LOWER SNAKE RIVER ICE HARBOR and LOWER MONUMENTAL LOCKS and DAMS

**Adult Fishway Systems
Emergency Auxiliary Water Supply
Phase II - Technical Report**

August 1999

An independent technical review was performed on this Phase II - Technical Report at the 60 percent level of completion. The quality control plan for the technical review is included in appendix A. The technical review comments and the responses to them are included in appendix B.

LOWER SNAKE RIVER
ICE HARBOR LOCK AND DAM
EMERGENCY WATER SUPPLY
POWER ONE-LINE DIAGRAM
NORTH SHORE ALTERNATIVE 1 & 2

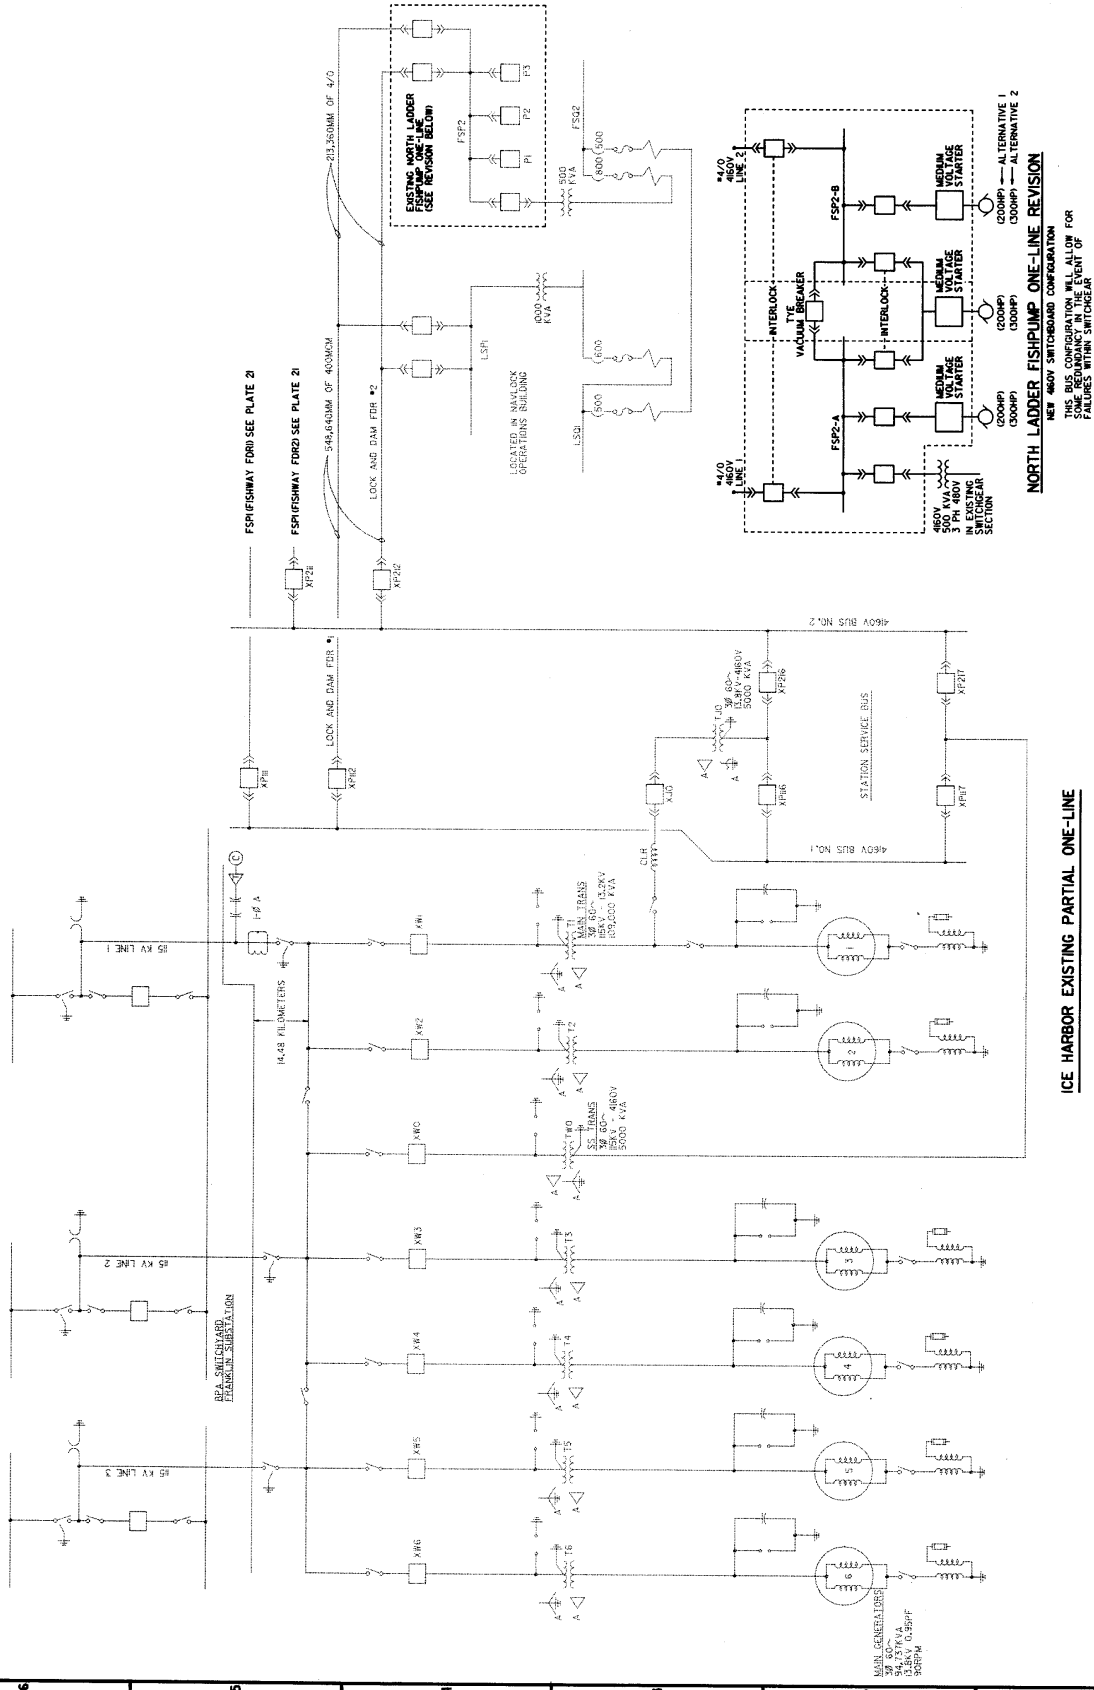
9.	Plates 3, 18	Callout run lengths of cable in meters not MM.		A		C	
10.	Plate 3	Correct spelling of "TYE" Breaker.		A		C	
11.	Plate 18	List voltage class of the switchboards for the 3 options fed from LSQ1.		A		C

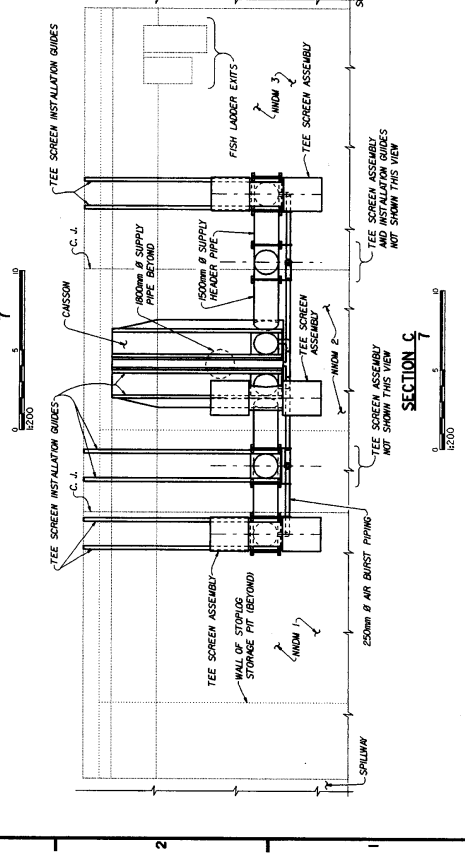
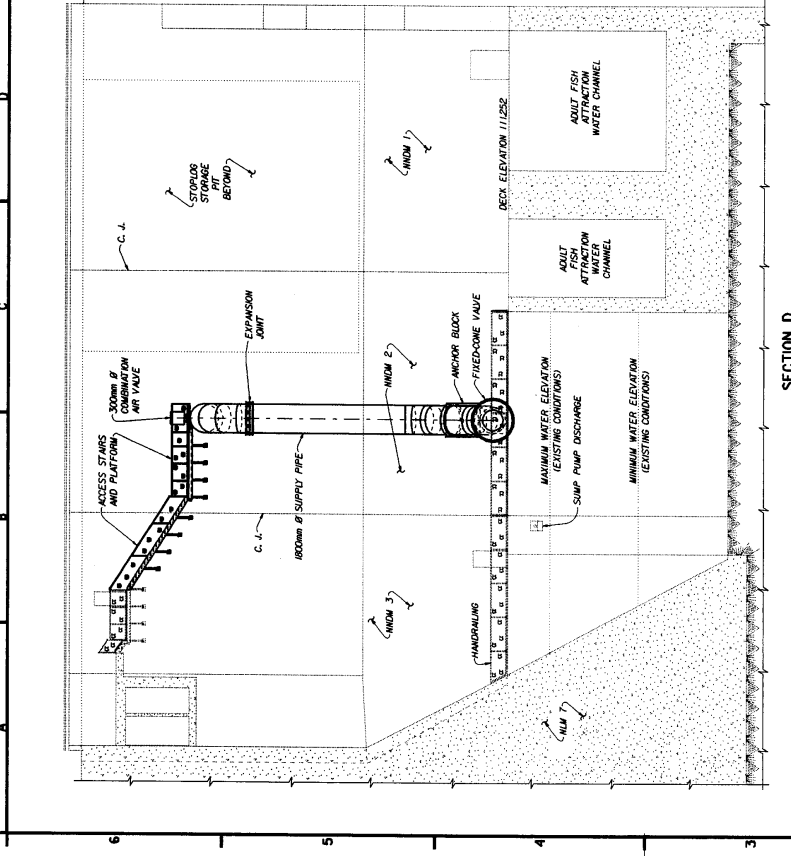
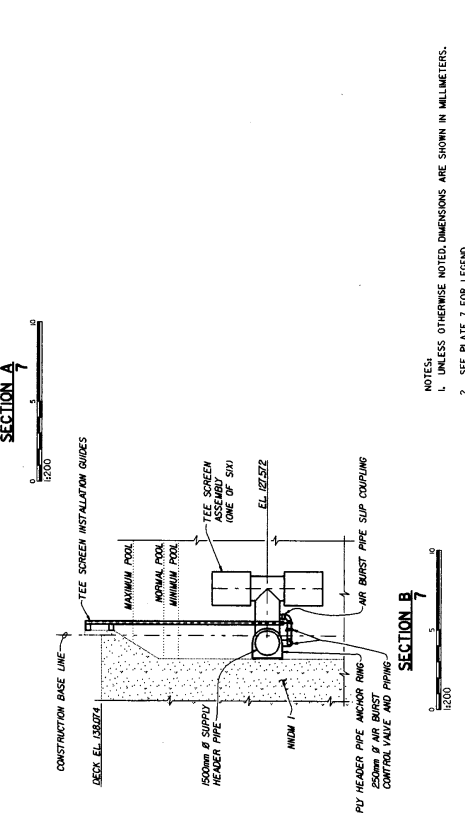
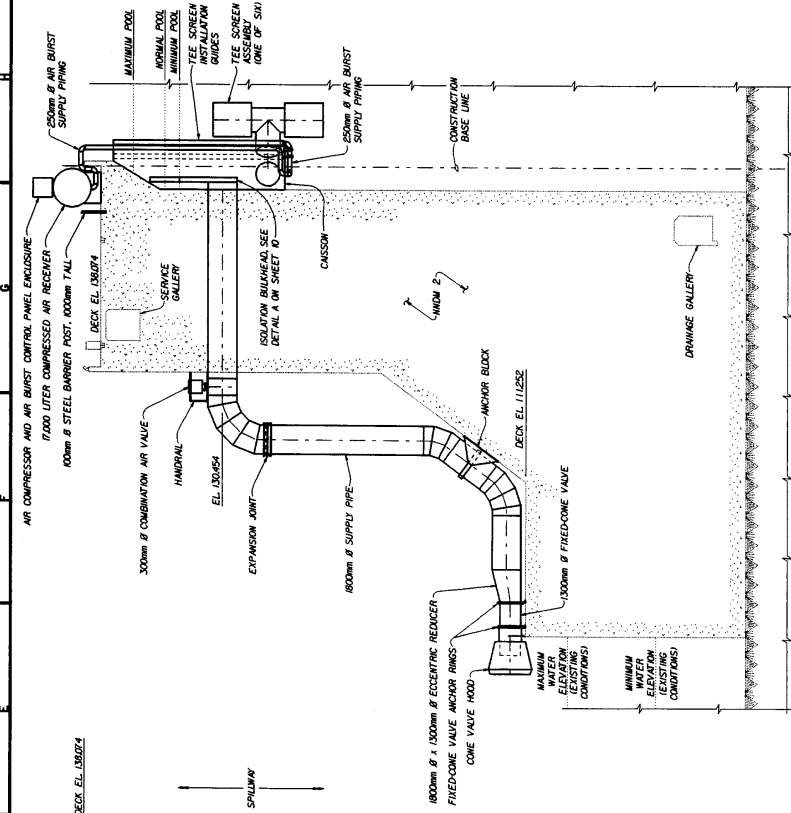
Plate 7	Is there a loading scenario may cause this structure to want to float, slide or overturn? This may include seismic with unbalanced head.	A		The structure is ok for overturning.	<i>MC</i>
6	Plate 7	Will there be a loading scenario that causes the walls of slabs in this structure to become overstressed?	A		Will perform further analysis.	<i>MC</i>
8	Plate 15	What carries the weight of the in-line sleeve valve? Is the existing structure adequate to carry these loads?	A		If this method is selected, we can perform an analysis during plans and specs.	<i>MC</i>
9	Plate 35	Can this be used for Ice Harbor for temporary caisson option?	A		Possibly	<i>MC</i>
10	Plate 32	Any selected method should include a consideration of seismic effects upon the existing nonoverflow section. However, the effects are probably minor.	A		If this method is selected, we can perform an analysis during plans and specs.	<i>MC</i>
